Planning & Zoning Board Meeting

September 22, 2022 at 6:00 PM

TO: Town of Howey-in-the-Hills Planning Board
CC: J. Brock, Town Clerk
FROM: Thomas Harowski, AICP, Planning Consultant
SUBJECT: The Reserve/Hilltop Groves First Amendment to the Development Agreement
DATE: September 12, 2022

TO: Howey-in-the-Hills Development Review Committee
CC: J. Brock, Town Clerk
FROM: Thomas Harowski, AICP, Planning Consultant
SUBJECT: The Reserve/Hilltop Groves First Major Amendment
DATE: August 30, 2022

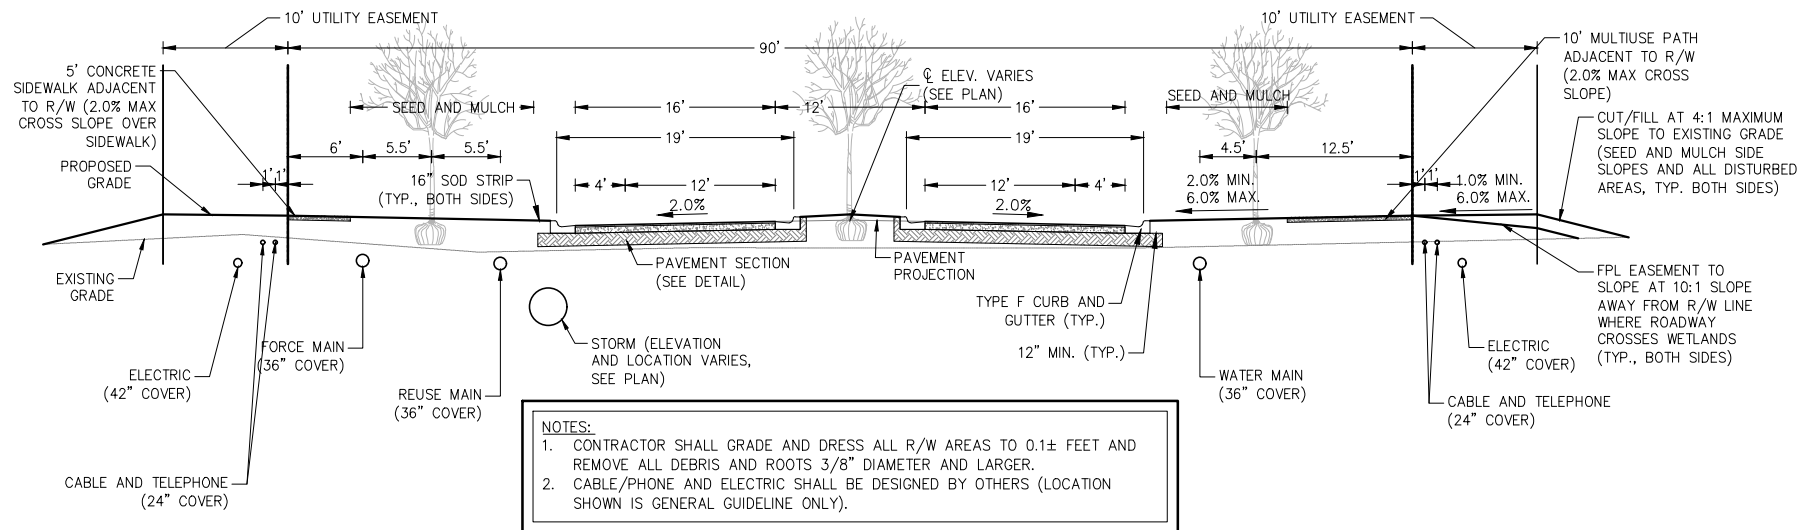
In addition to the above items, we submit the following summary of the revisions on the attached redlined Master Site Plan from the original approval PUD exhibit. The project has now begun detailed engineering design and a greater level of detail is now shown. Each number below corresponds with a number listed in red on the Master Site Plan

1. The roadway alignment has been revised to create a safer condition for both pedestrians and vehicles.
2. The entrance roadway connection to S. Palm Drive has shifted south approximately 250'.

5. The emergency access adjacent to a stormwater pond at the north side of the project has been removed.
6. A roadway connection is added between phase 2 and phase 3 in lieu of a cul-de-sac in phase 2.

7. The driveway apron pictorially shown previously has been removed.
8. Lots are revised to be 50'x115' lots in lieu of 50'x80' lots.
9. A roadway connection is shown connecting all of phase 4 development.

10. Added stormwater management facility locations.
11. The phase line revised so that spine road connection to Number 2 Road is included in phase 1.

12. The right of way between S. Palm Drive to the project boundary is revised to be a 100' wide to allow for additional green space for tree plantings.
13. Other minor revisions that are a result of additional progress on detailed design that are not numbered but are identified here are:
 - a. Shifting of lot lines
 - b. Relocation of Pump Stations
 - c. Addition of Natural / Vegetative Upland Buffers
 - d. Pond banks and normal water lines more accurately depicted

TYPICAL ROADWAY CROSS SECTION FOR 90' RIGHT OF WAY

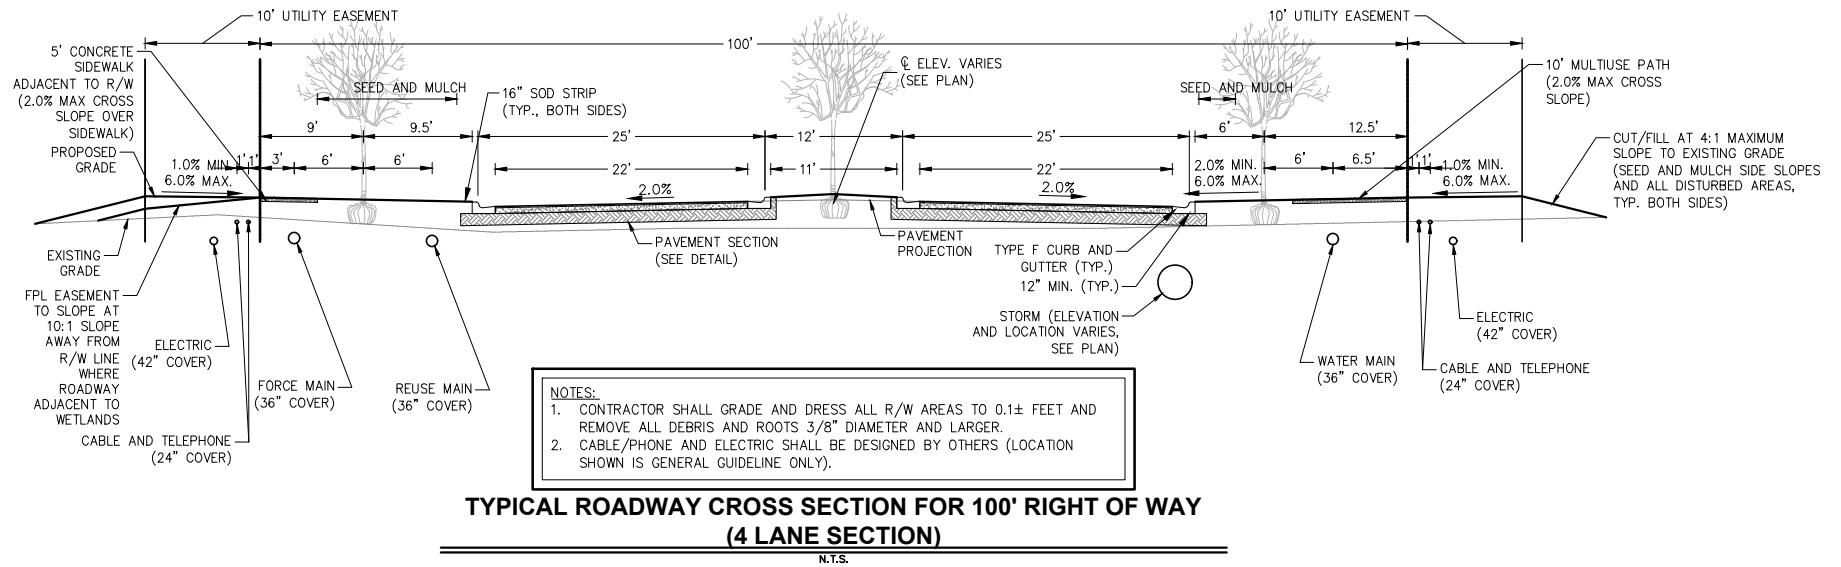
4. The applicants are revising the collector road cross-sections to include the minimum 10-foot bicycle/pedestrian pathway that extends from SR 19 to Number Two Road. This facility has been a commitment of the project, but roadway cross-section submitted prior to this plan did not fully identify the bicycle/pedestrian path. **(Refer to the revised cross-sections for the two-lane and four-lane sections.)**

june engineering consultants, inc.	23 W. Joiner Street Winter Garden, FL. 34787 Ph. 407-905-8180 Fax 407-905-6232		JOB NO. 07-0398
	Certificate of Authorization #00008507		SHEET 6 OF 10
DRAWN BY: CLK DATE: 2/4/08	CHECKED BY: RAJ DATE: 2/4/08	SCALE 1" = 50'	JEFFREY A. SEDLOFF PE# 51506

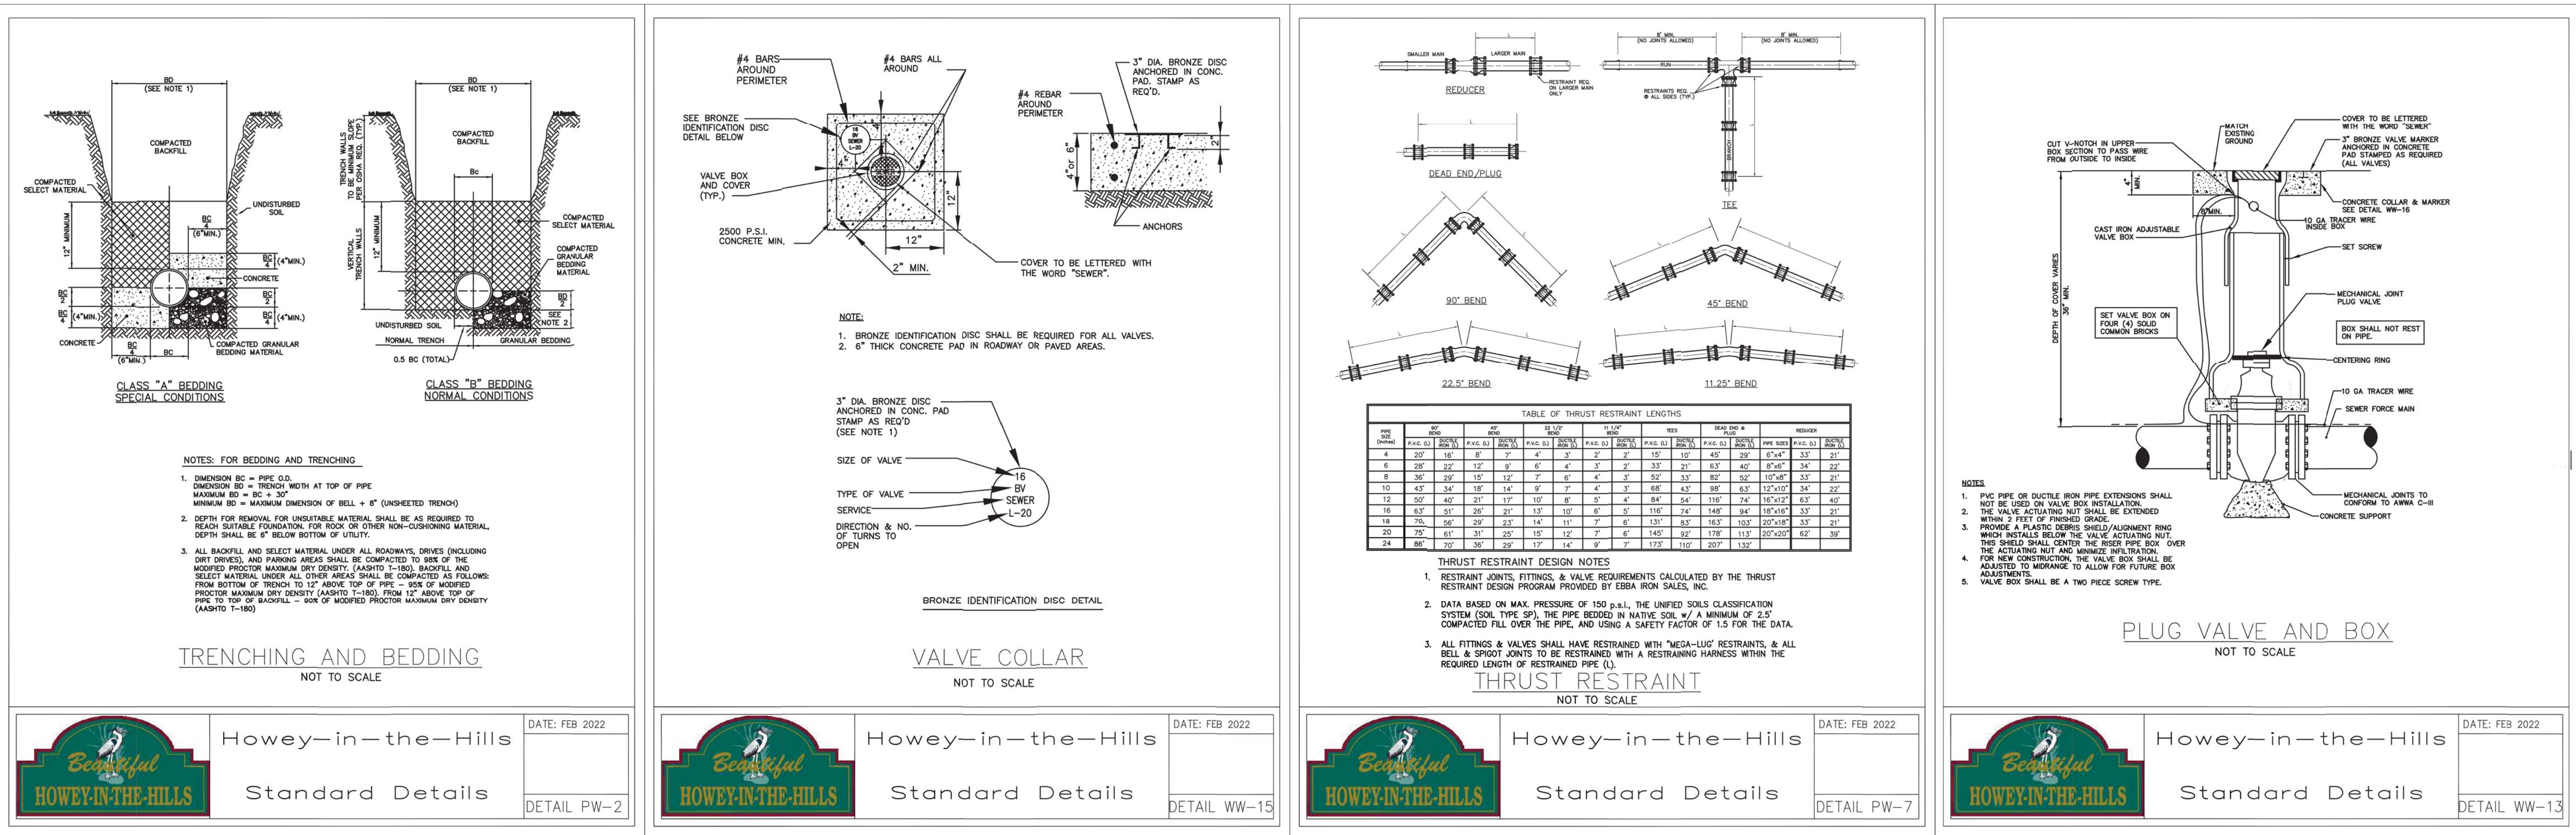
9. Update the Utility Connection Detail on sheet 6 to add the ex. 4" WM, correct the new WM size, remove the FM connection note.

10. Identify on the plan the water main jumper locations and BacT testing points. Add the town's temporary jumper detail PW-5A.

RESPONSE: The existing 4" water main has been shown on sheet 6 of the revised plans. We have shown this main to remain.

RESPONSE: Sample points SP-1, SP-2 and SP-3 are shown on sheet 6. The temporary jumper detail is shown on sheet 9.
